CASE #PL2020-79

STARGATE - BLOOMINGTON
TENANT REMODELING IN EXISTING TENANT SPACE
6203 8TH WEST 11TH STREET
BLOOMINGTON, MN 55438
ENLARGED FLOOR PLANS

STARGATE - BLOOMINGTON
TENANT REMODELING IN EXISTING TENANT SPACE
6203 8TH WEST 11TH STREET
BLOOMINGTON, MN 55438
PARTIAL EXTERIOR ELEVATIONS

1 PARTIAL SOUTH ELEVATION - NEW
SCALE: 1/4" = 1'-0"

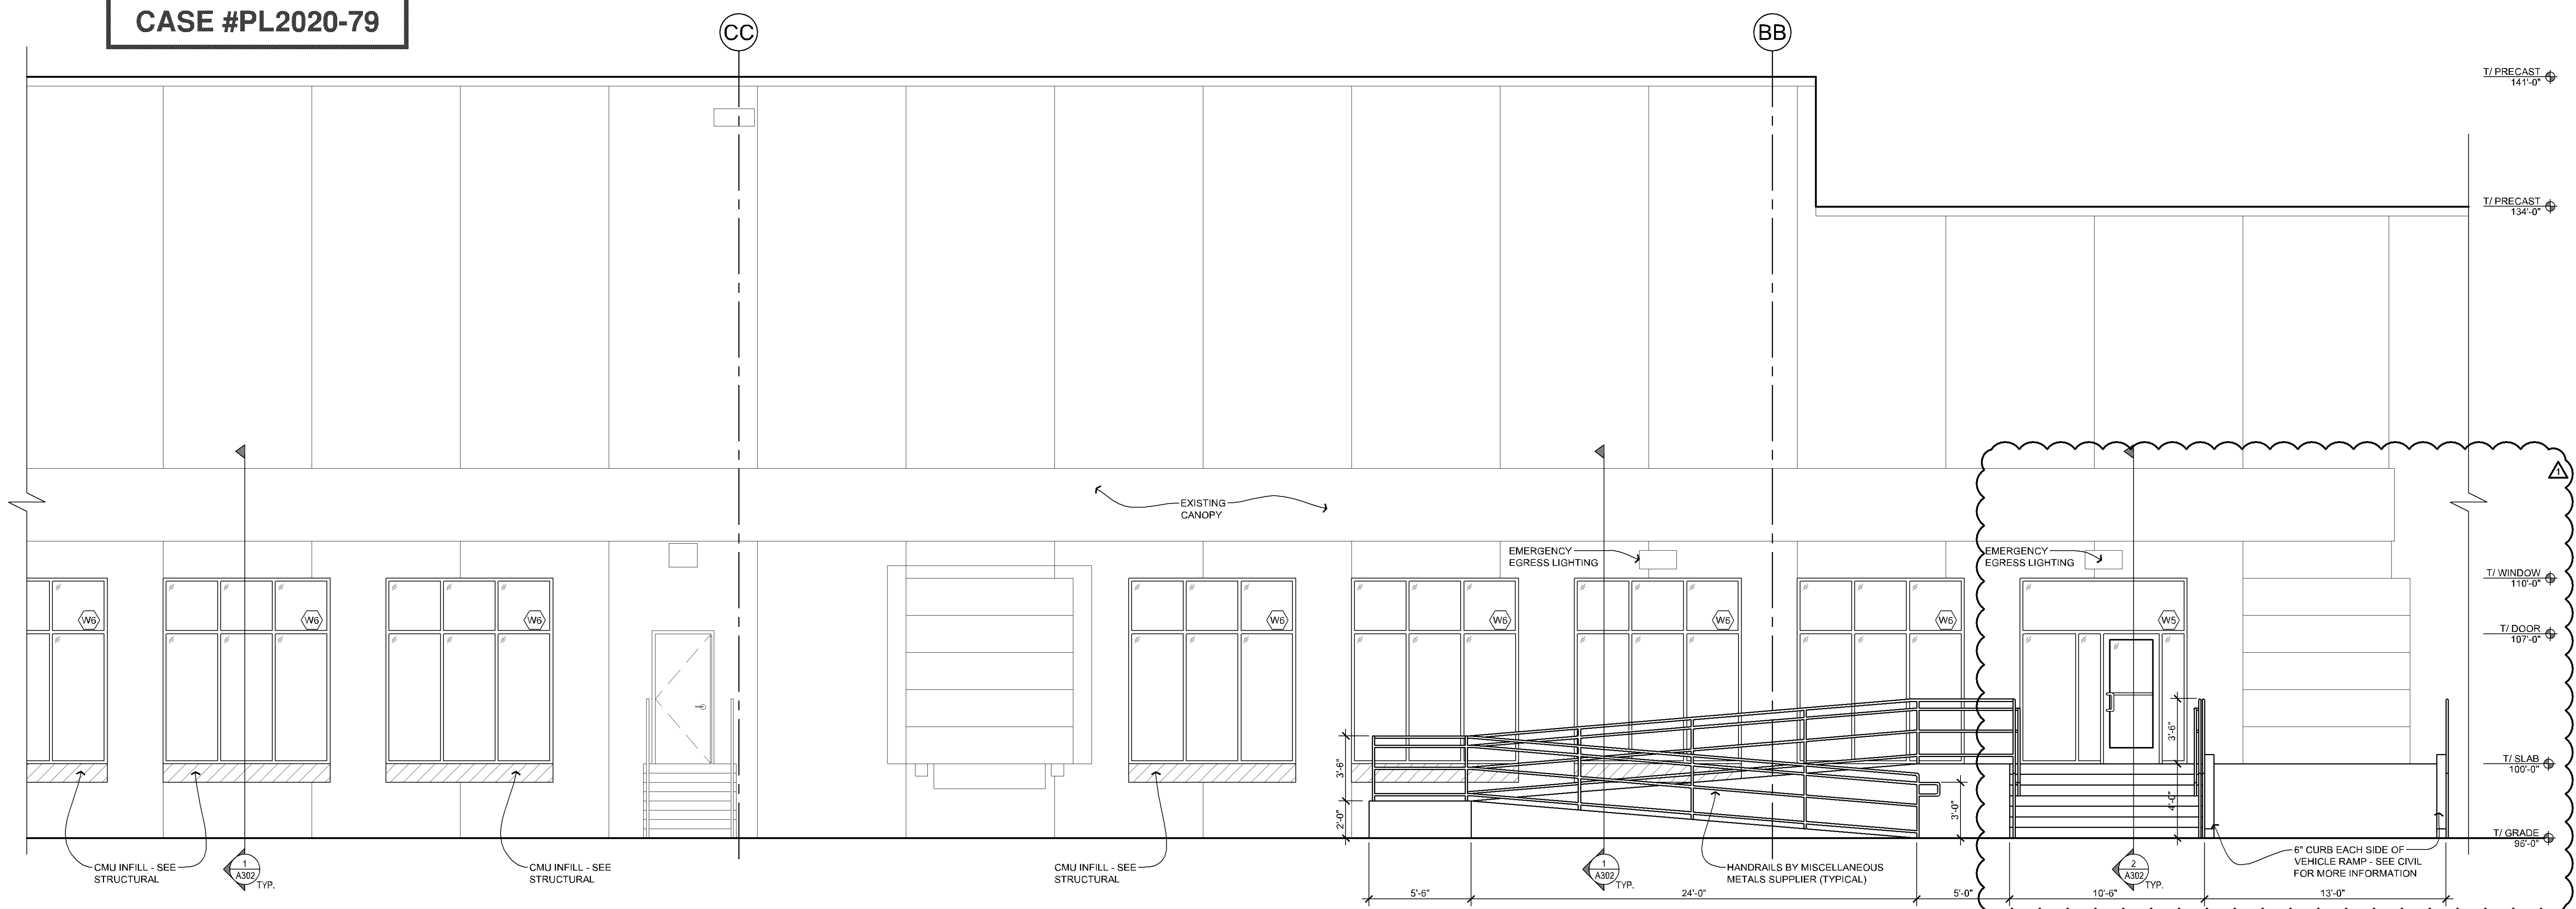
Must meet 2015
MN State
Accessibility Code
